**DESIGN REVIEW BOARD WORK SESSION**

**Design Review Board Case # 2020-00001**  
**Block P – 765 John Carlyle – South Tower**

**Block P – DRB Work Session**

*Above: Staff’s sketch as related to item A-1. above.*

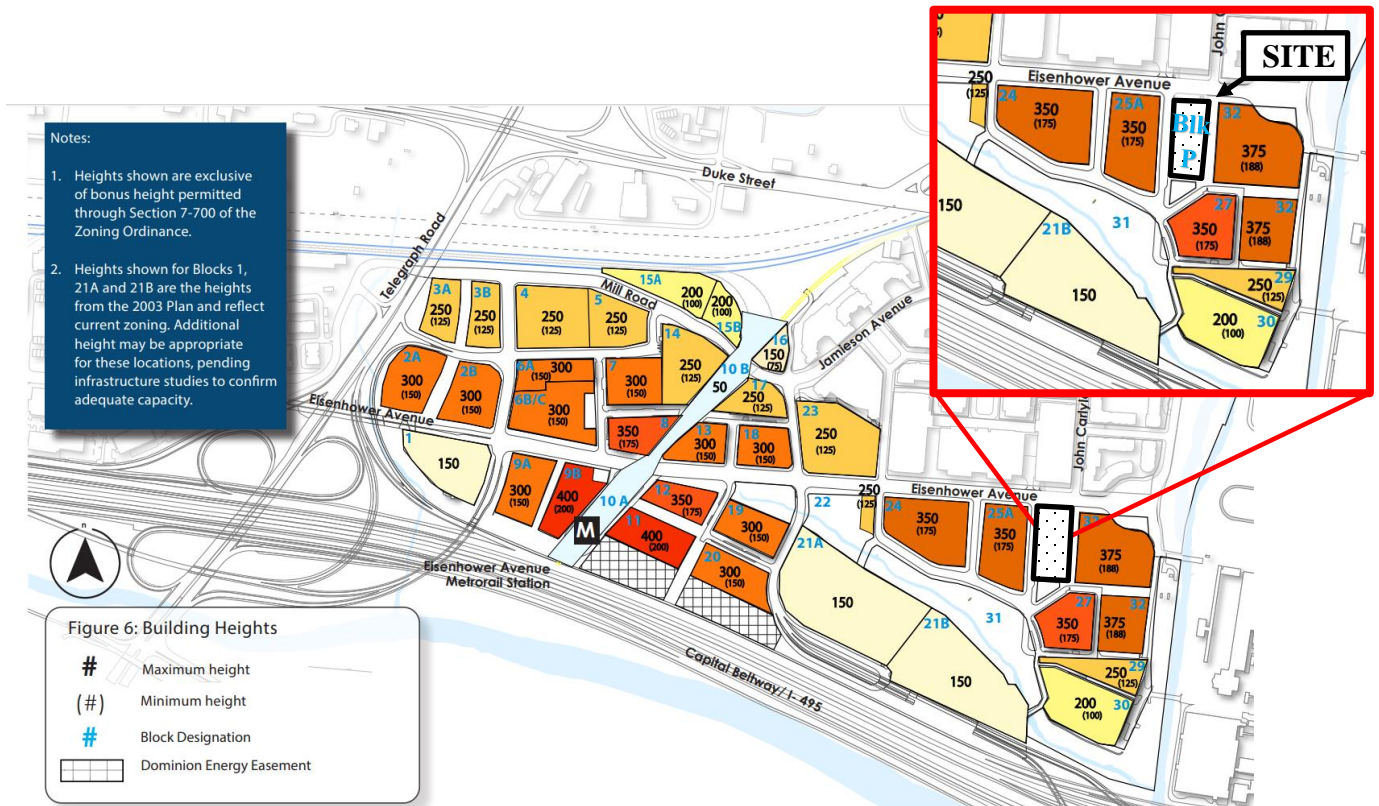
As noted above, the south tower presents not only a change in floor area program, but also in height, density and massing. And as mentioned, these changes require an amendment to the existing SUP – which necessitates an appearance before City Council. In spite of the additional legislative requirement, the changes to the previously approved office tower’s architectural envelope, height and massing are warmly received. The heights proposed are also in keeping with those outlined in the newly adopted Eisenhower East SAP – which envelops the site from the west, south and east. However, some refinements are necessary at the penthouse level. To this end, the applicant should consider the following with the next submission:

1. Consider lowering the height of the connector piece to emphasize the verticality of the towers. (see sketch below)
2. Additionally, consider aligning the face of the penthouse (along *future* John Carlyle Street) with the bulk of general massing of the building for said reasons. (also see sketch below)

## B. Parking

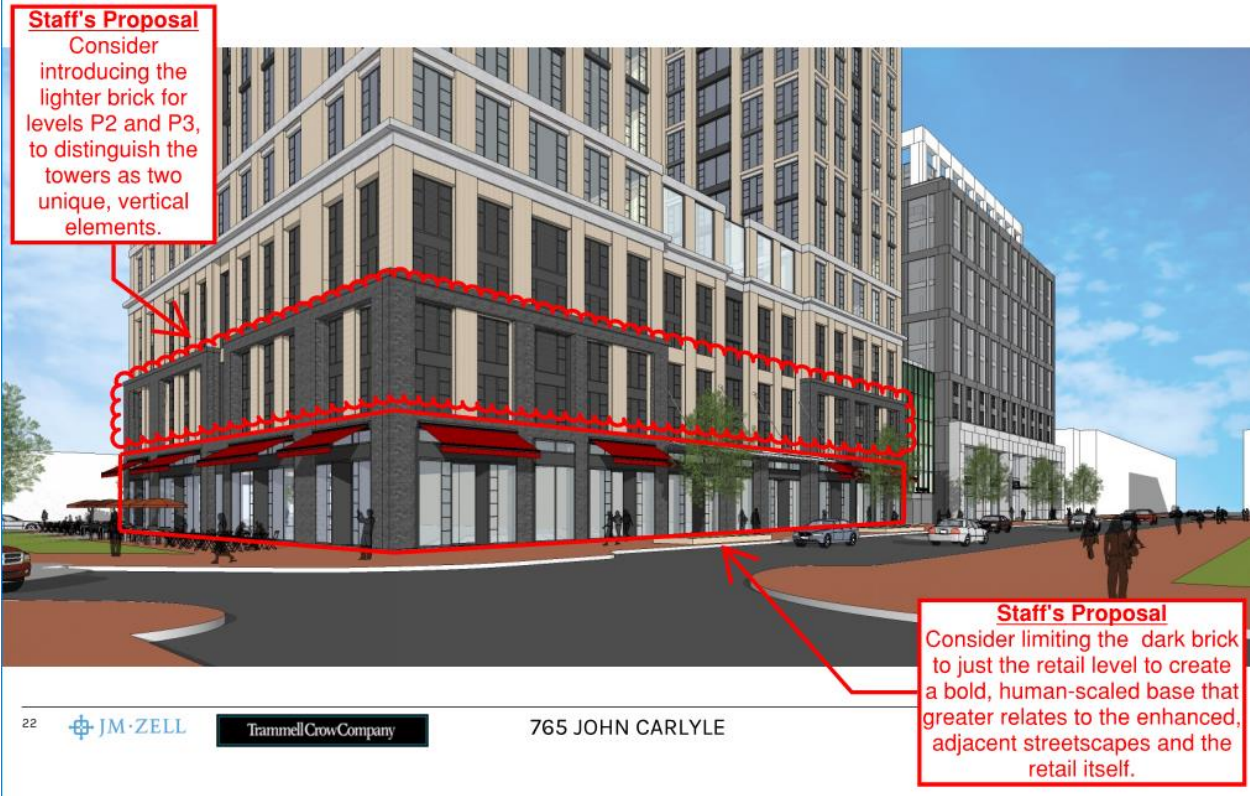
With this iteration, the applicant has reverted to the previously approved garage level screening in which is a system of spherically-perforated metal panels arranged to mimic typical windows are utilized. However, the graphics themselves, as described more thoroughly in section E – Graphics, contain inconsistencies which shall be reconciled prior to final approval.

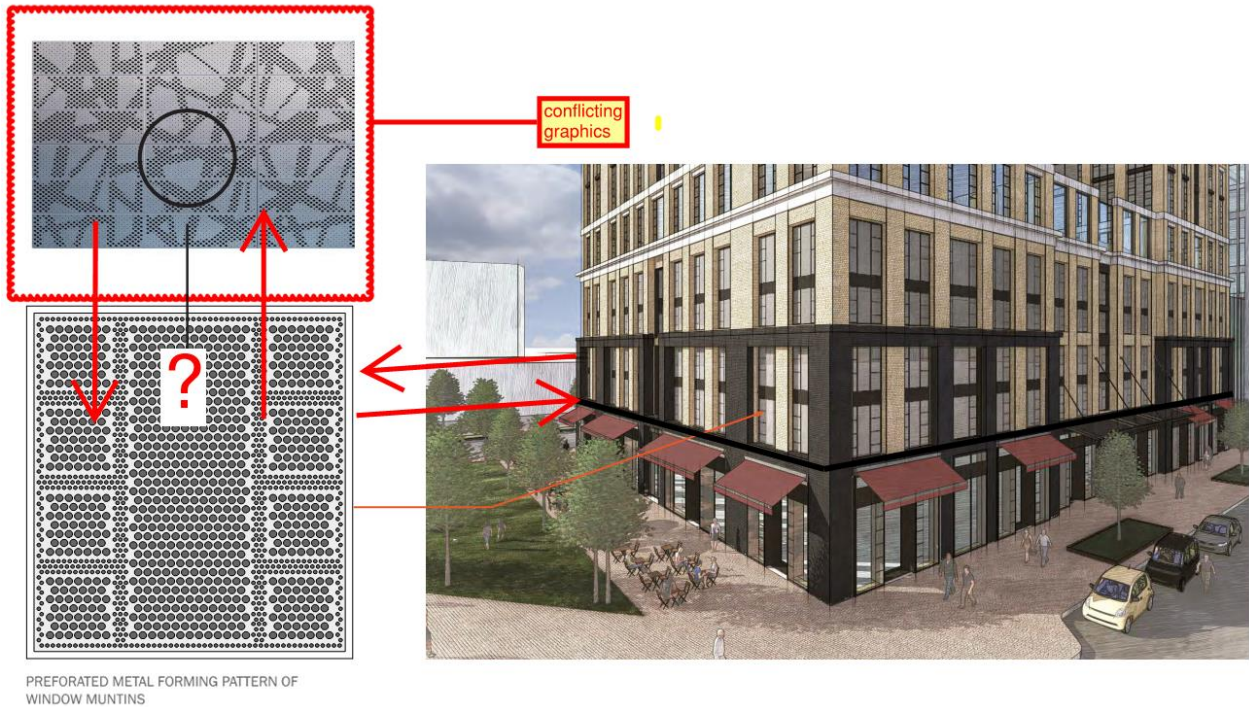
As previously noted, the dark brick materiality – apparently superimposed on the south tower base to relate to the lower base datum line on the north tower – detract from the strong base of the southern building. A more successful application would be to use the materiality to express only the retail level of the podium, and to revert to the lighter brick, as noted in the markup below.

Additionally, the change in the awning's materiality from an industrial expression to an apparent "wind-up" variant is concerning from a design, safety and operational perspective. Therefore, the Applicant shall revert to the original, steel and glass awning, which better relates to the modern, refined architecture of the block.

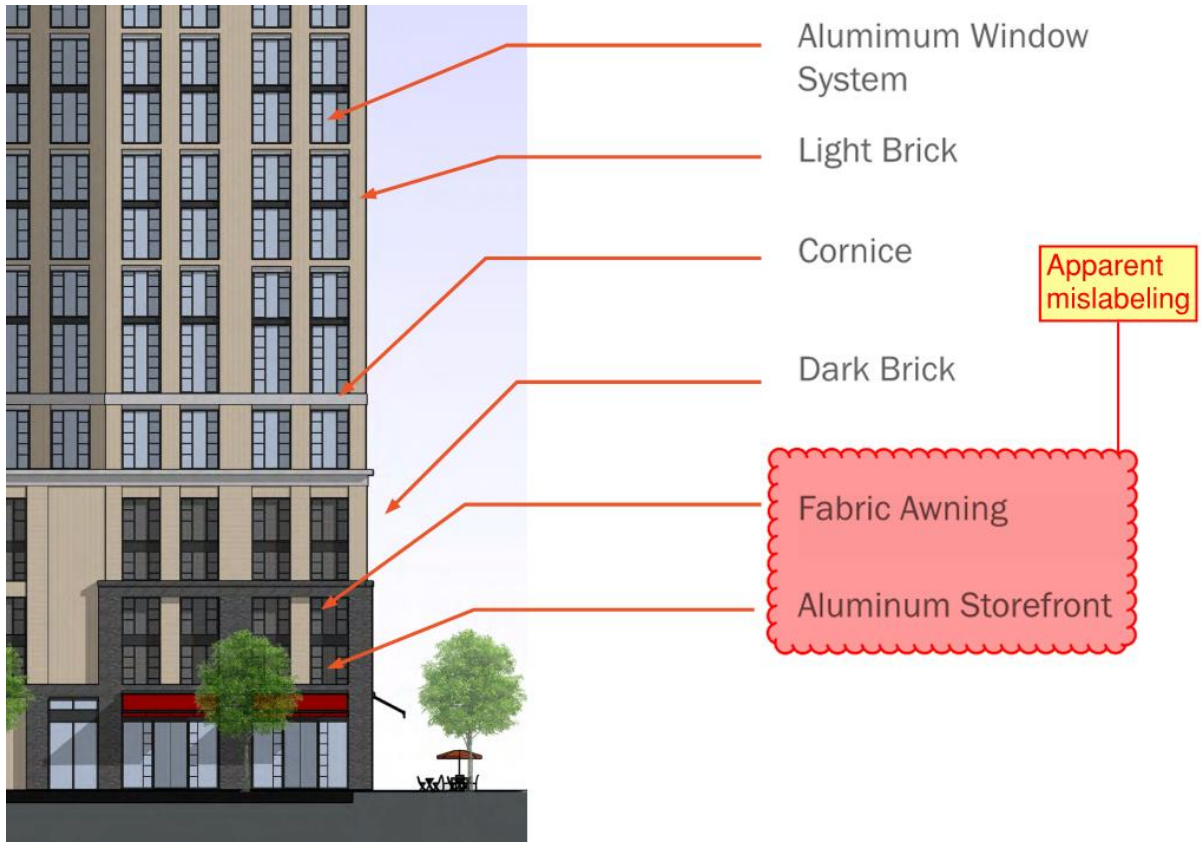
The graphics with this submission are a general improvement. However, those which depict the perforated metal screening used to conceal the above-grade garage levels (P2 – P5, see below) are inconsistent and must be reconciled.

There are also inconsistencies with the labeling of the materiality, as illustrated in a markup below. therefore, all elevations shall be reconciled to include the correct material call out.
